TechFact

TechFact – ThinLINE® Unit Discharge Pressure Regulator Valve (DPRV) Removal

TechFact - Product Update (ThinLINE® Recip Compressor Sight Glass)

TechFact - Product Update (Electronic Expansion Valve)

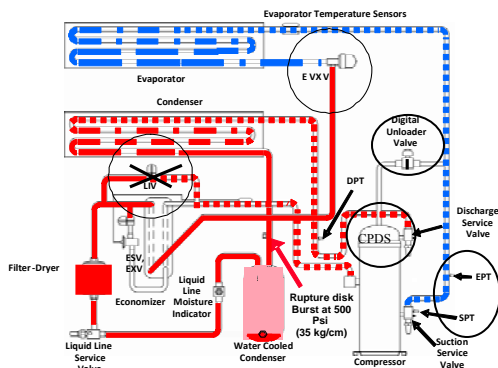
The purpose of the DPRV on the ThinLINE® unit is to ensure compressor lubrication is maintained when operating under low load, low ambient conditions. As a result of extensive research conducted using the ML3 controller and the stepper suction modulation valve, we were able to qualify new software logic that improves oil management, allowing us to remove the DPRV and simplify the unit.

Accordingly, on ThinLINE unit model numbers (69NT40-541-xx) with PID 2000 or greater, the DPRV has been removed from unit.

If a DPRV requires servicing in a unit, then it can be removed from the unit provided it has an ML3 controller with software version 5147 or greater and a stepper modulation valve. Otherwise, the DPRV will require replacement.

If the unit has both of these and the logic is installed, then the DPRV will operate in parallel to the new logic.
